Site Address: 2230 PORTOLA WY SAC

Nature of Work: (N)2ND DWELLING UNIT ABOVE A (N)DETACHED GARAGE

Rosen Carriage House
2226 Portola Way
Sacramento, California

Revision to 9806372

WEST ELEVATION

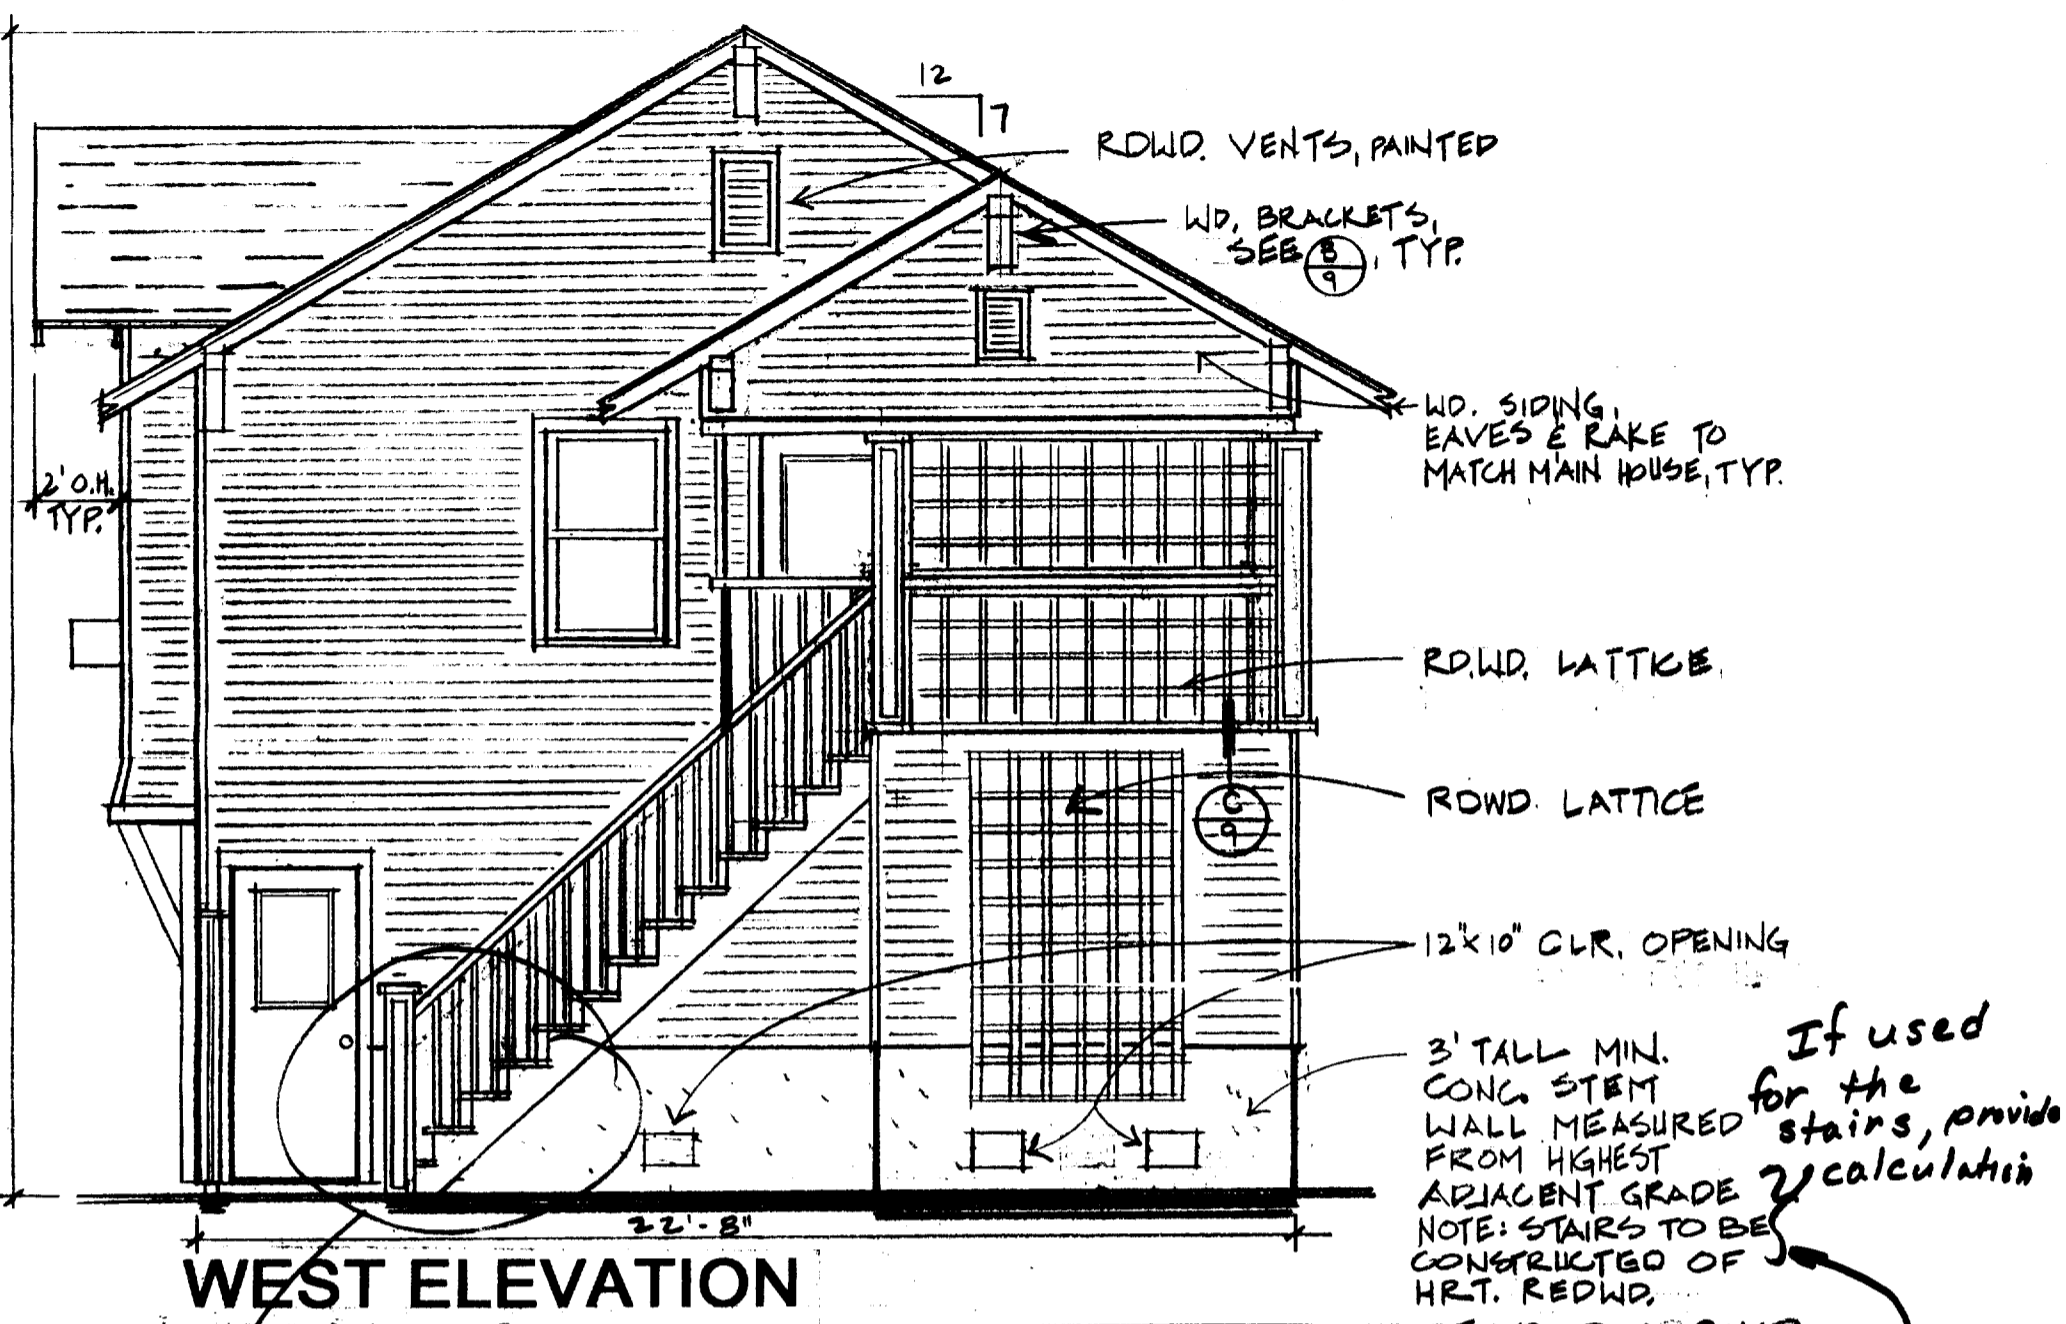
All wood ~~work~~ that is in the AR Flood shall be pressure treated for stairs etc.

NORTH ELEVATION

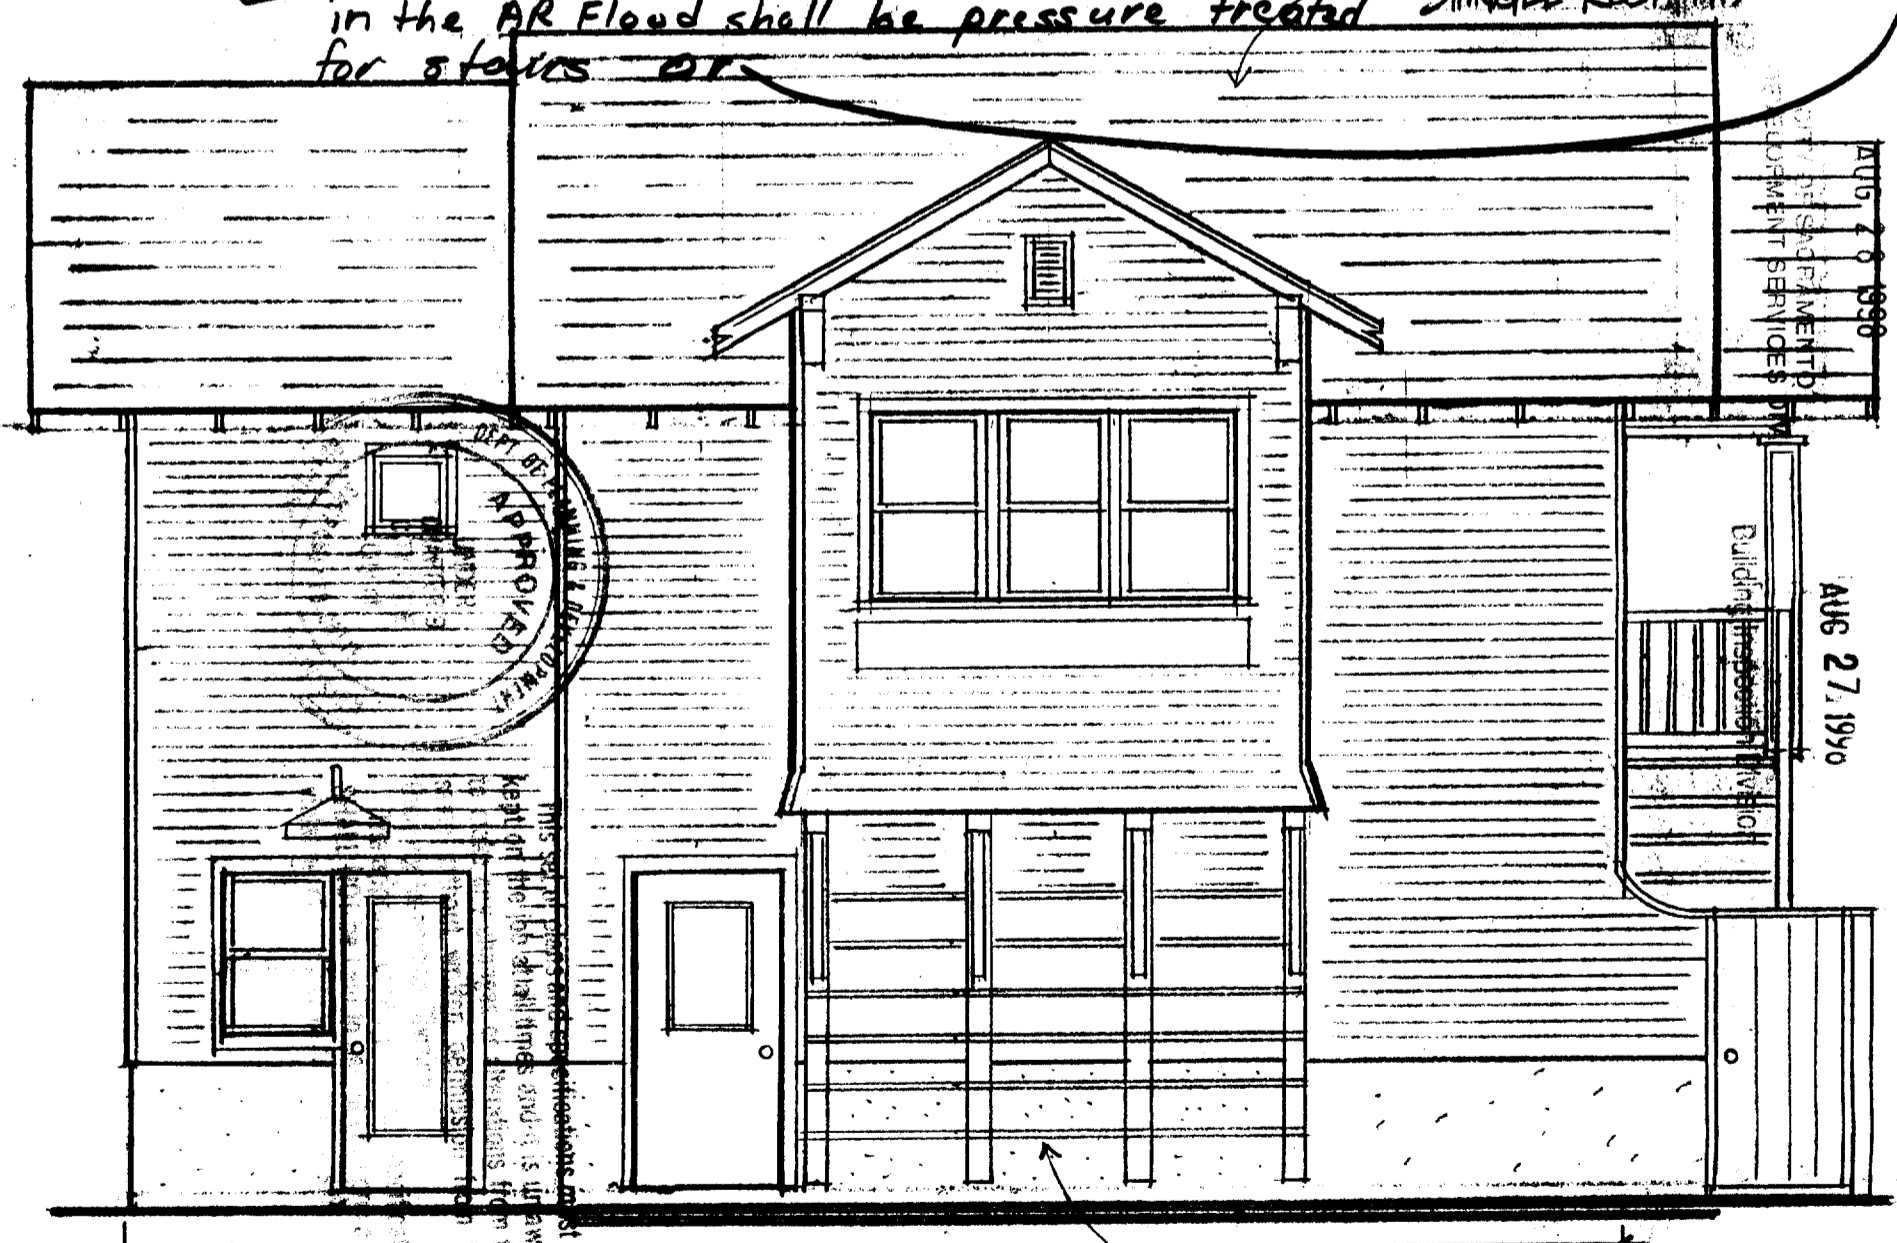
If used for the stairs, provide calculation

2nd FLOOR FRAMING PLAN

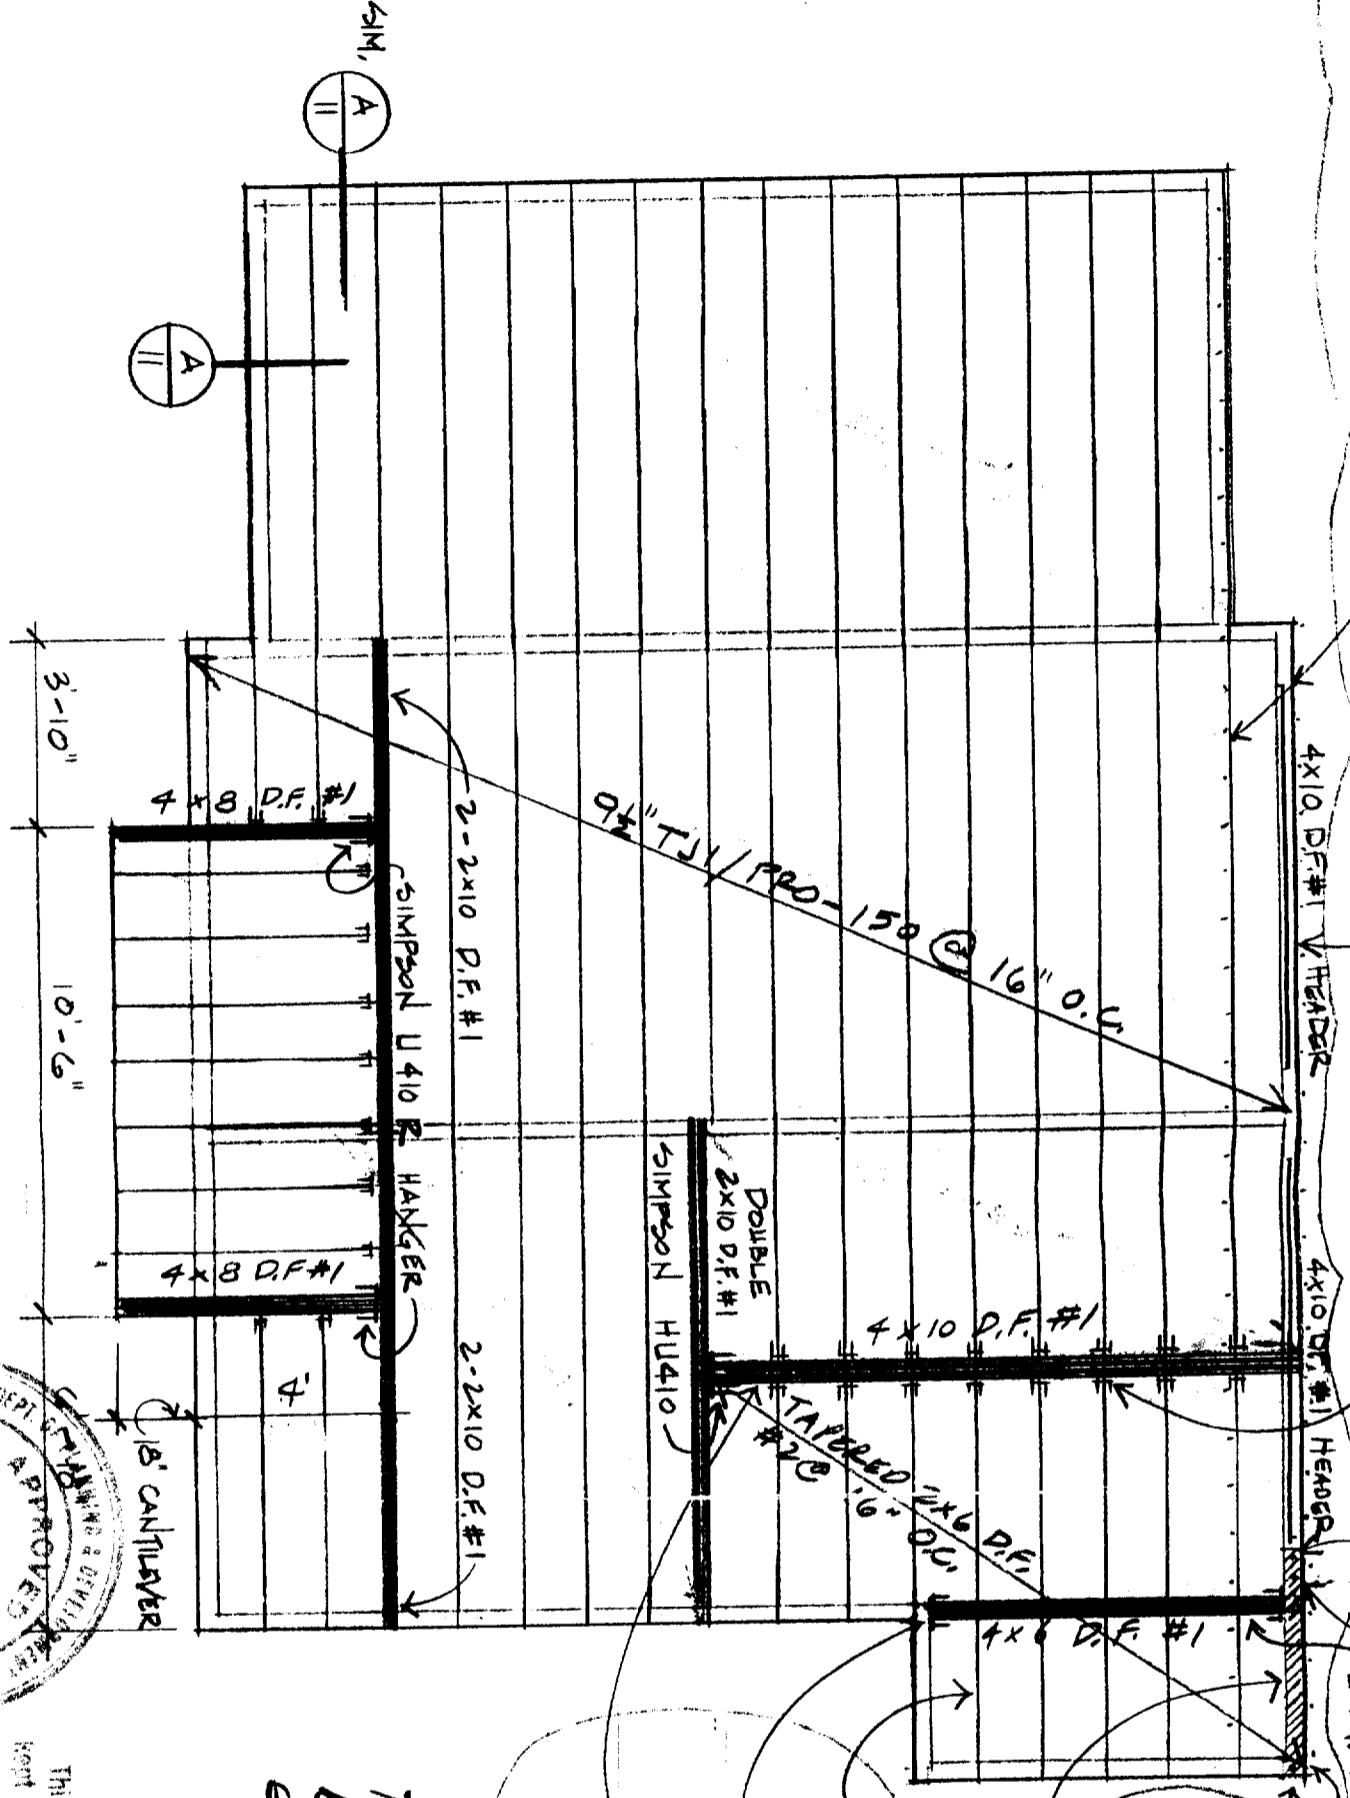
The 2 - 2x10's should not be used with the TJI ~~due~~ due to differential shrinkage RECEIVED

SITE PLAN

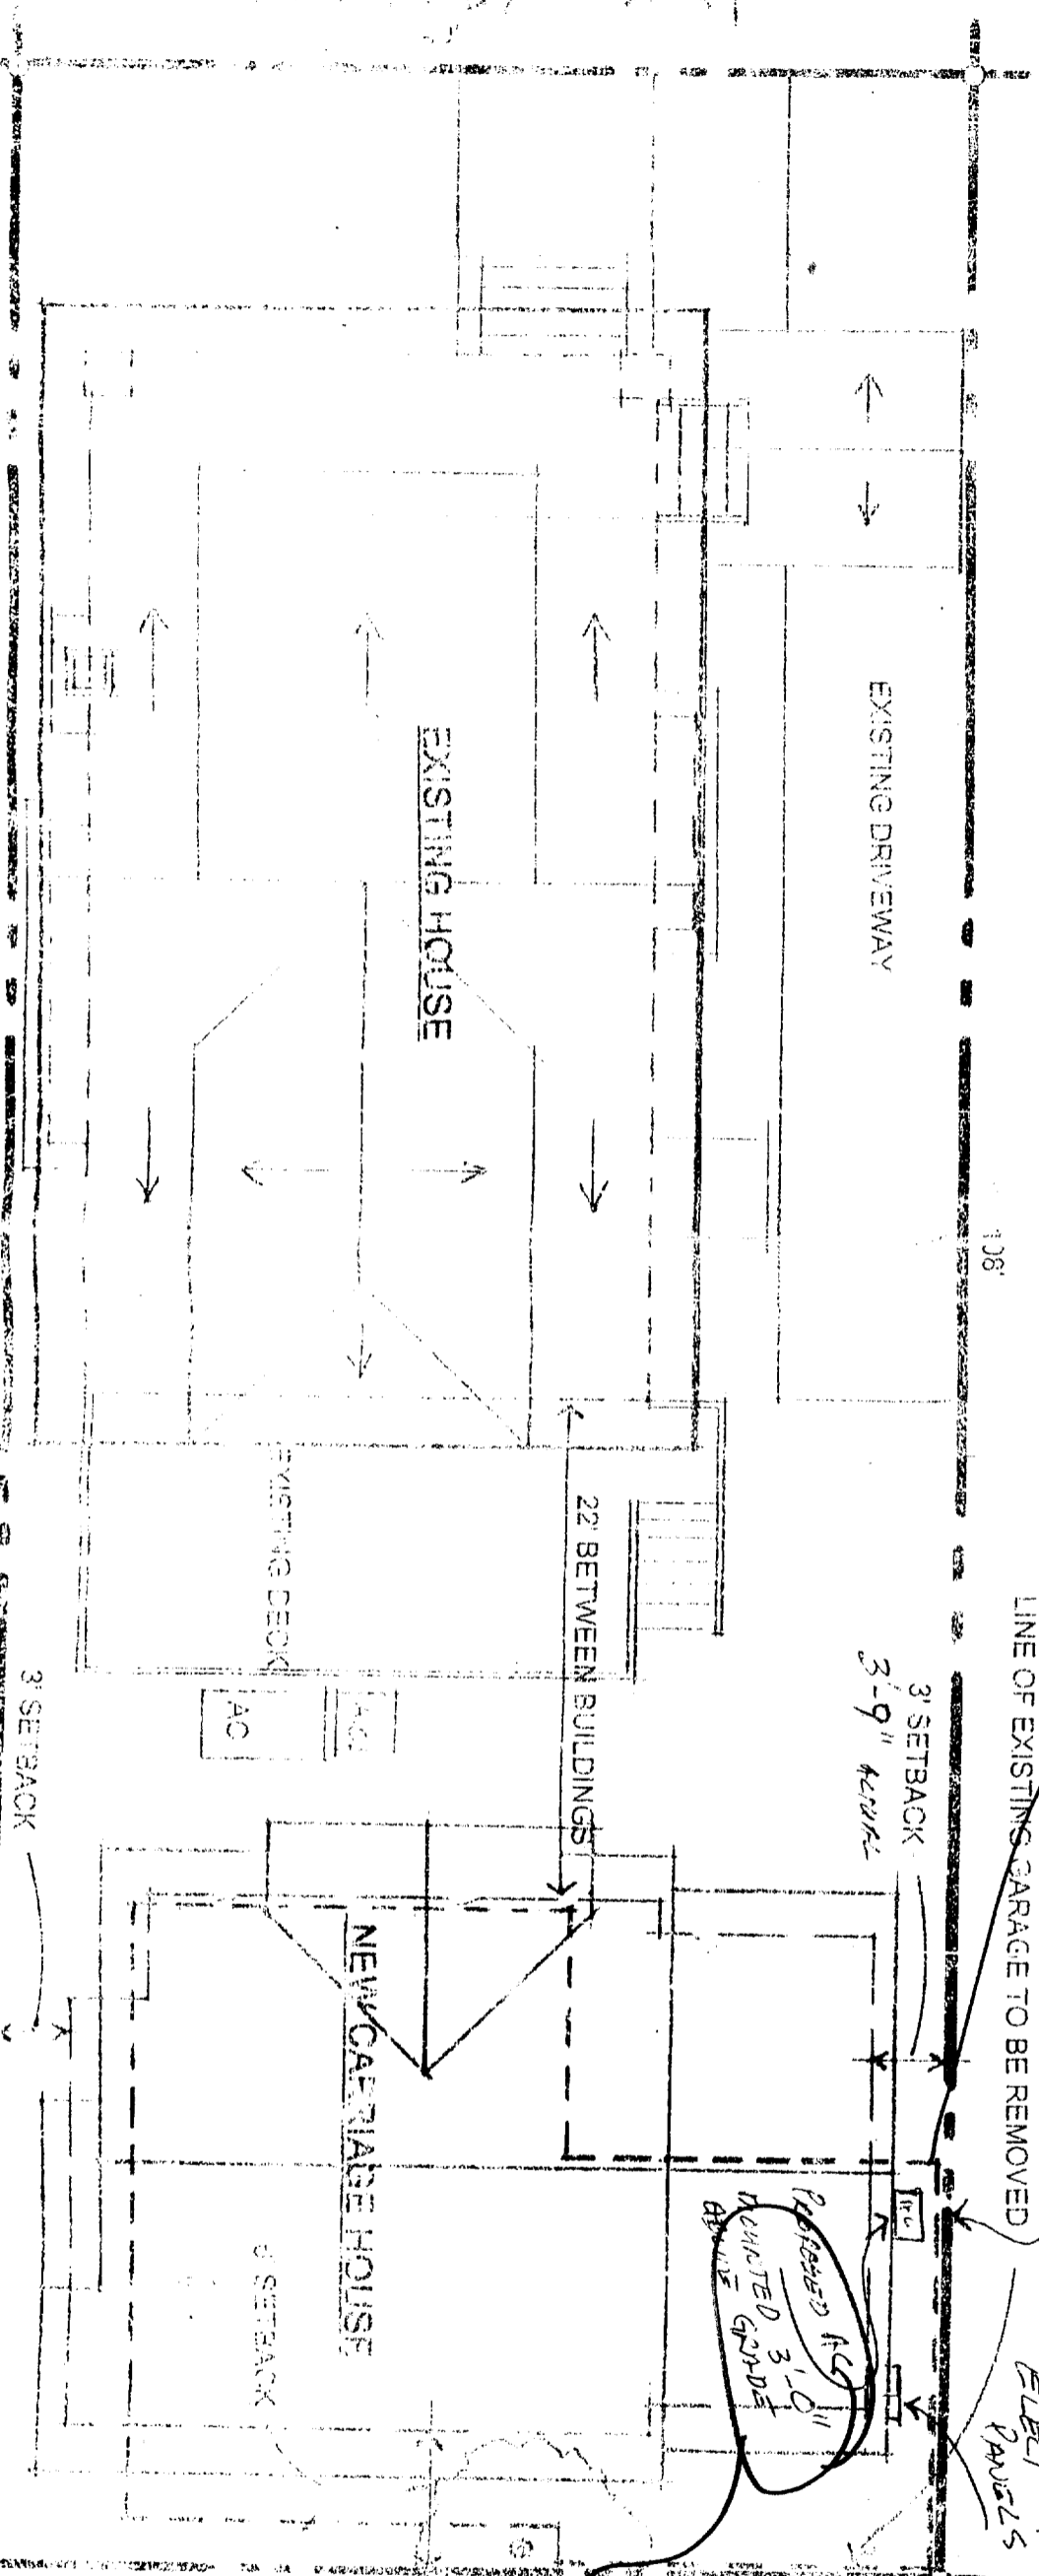
~~both reg'd by Planning~~
so HVAC unit is not
visible from street
per Planning

AR Flood
Regulation
reg's HVAC
unit to be
3' above
grade
1 JULY, 1991
